IN THE MATTER OF AN APPEAL OF THE
PLANNING COMMISSION DECISION FOR
THE **OREGON STREET INDUSTRIAL PARK**

FINAL ORDER 2008-001
SP 07-08

CITY OF SHERWOOD
NOTICE OF DECISIONFile No: SP 07-08
Oregon Street Industrial Building

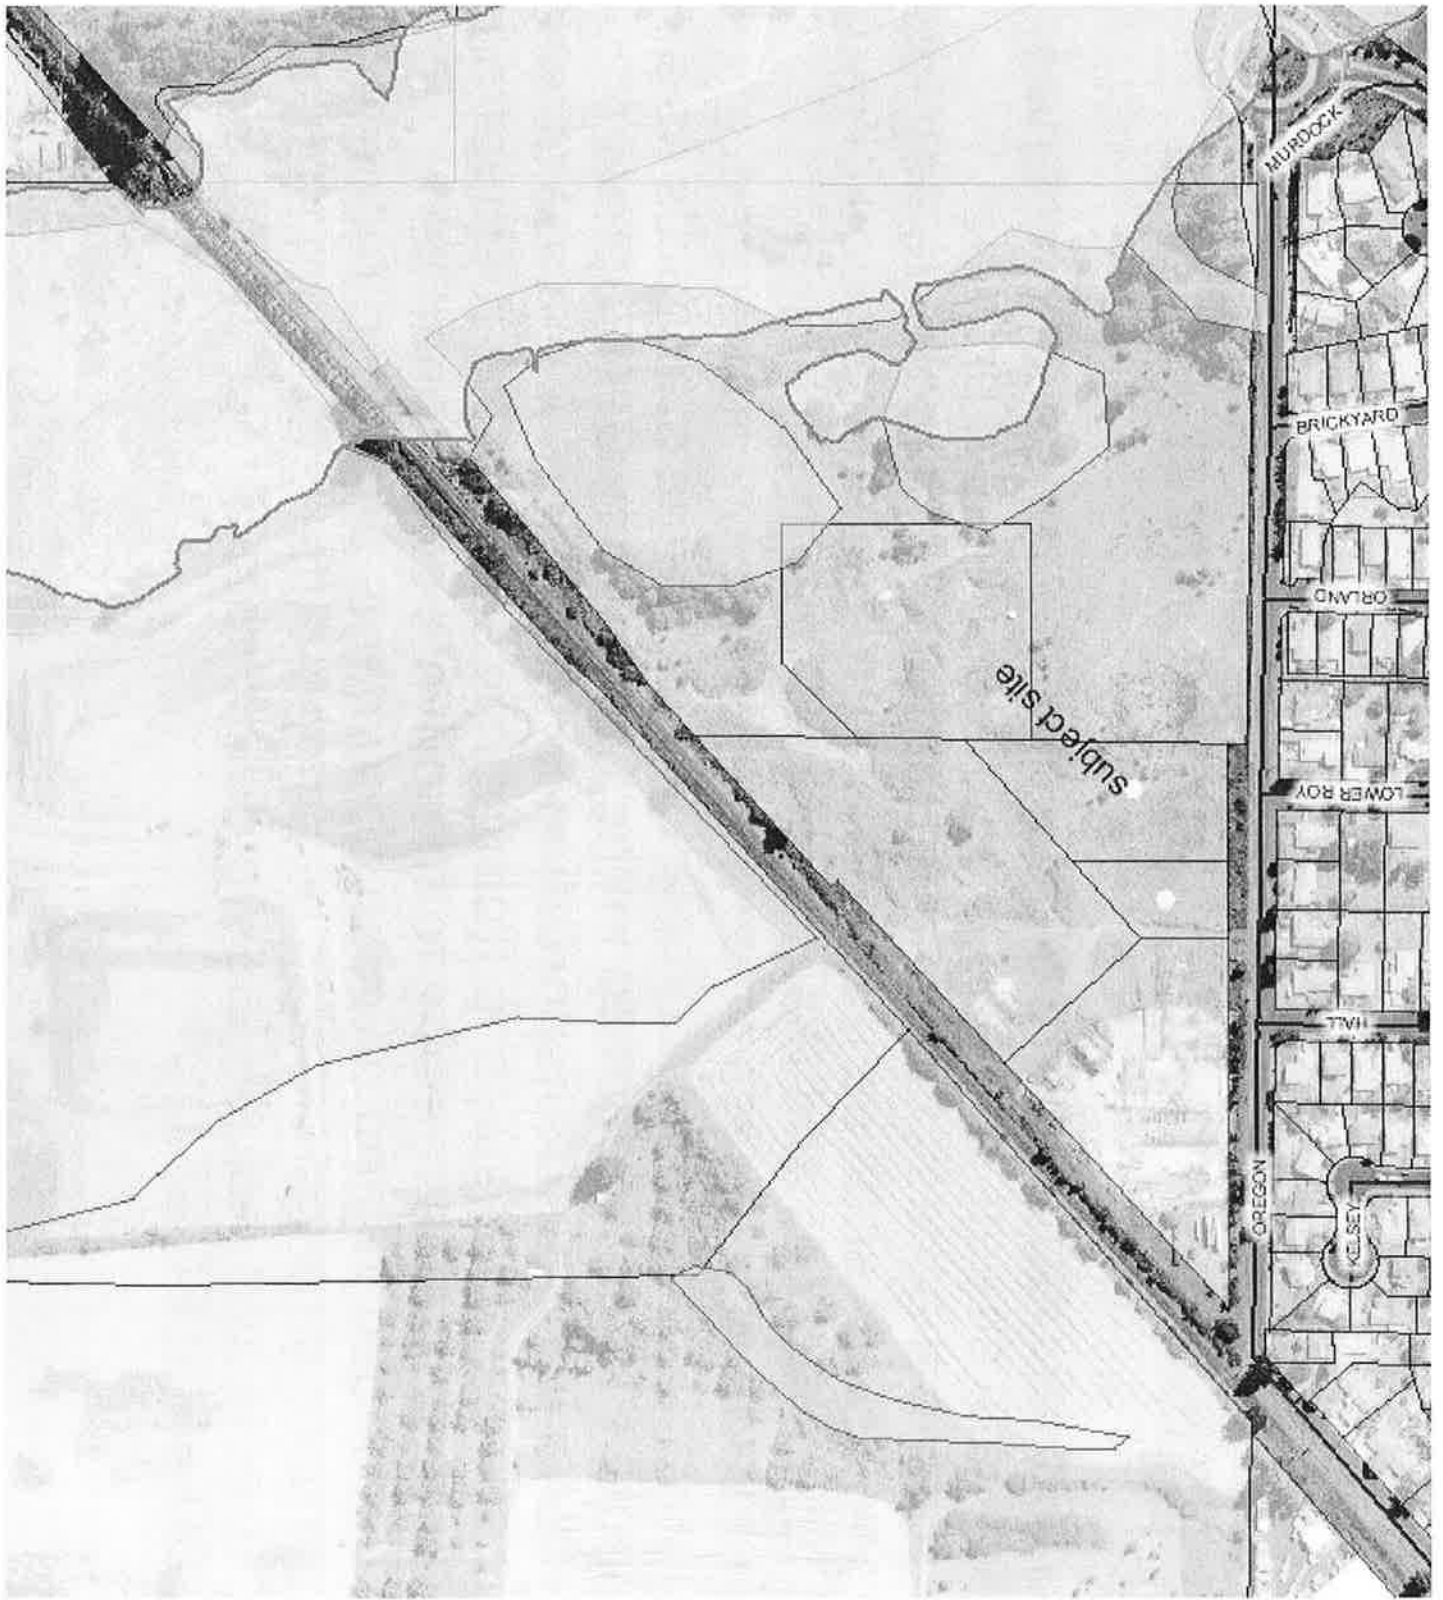
- Staff has evaluated the plans dated 11-15-08 submitted as Exhibit B in the Planning Commission packet and decision. It is possible to provide the required parking through a combination of parallel and perpendicular parking spaces.
 - Per section 16.94.020.02, 54 spaces are required without any reduction for multiple tenants.
 - 50 spaces were shown on the submitted plans
 - further reduced to accommodate ADA parking and meet required landscaping setbacks
 - Section 16.94.010.04 allows a reduction of up to 25% when multiple tenants are provided to account for cross-patronage.
 - Assuming a 25% reduction, 41 spaces are required and at least 42 could be provided utilizing the combination of parallel and perpendicular parking spaces.

- Combination of parallel and perpendicular spaces is necessary to comply with Section 16.94.020. B:
 - Parking space configuration, stall and access aisle size shall be of sufficient width for all vehicle turning and maneuvering. Groups of more than four (4) parking spaces shall be served by a driveway so that no backing movements or other maneuvering within a street, other than an alley, will be required. All parking areas shall meet the minimum standards shown in Appendix G.
- Because the private street is a street and must be built to public standards, Staff interprets this requirement to apply.
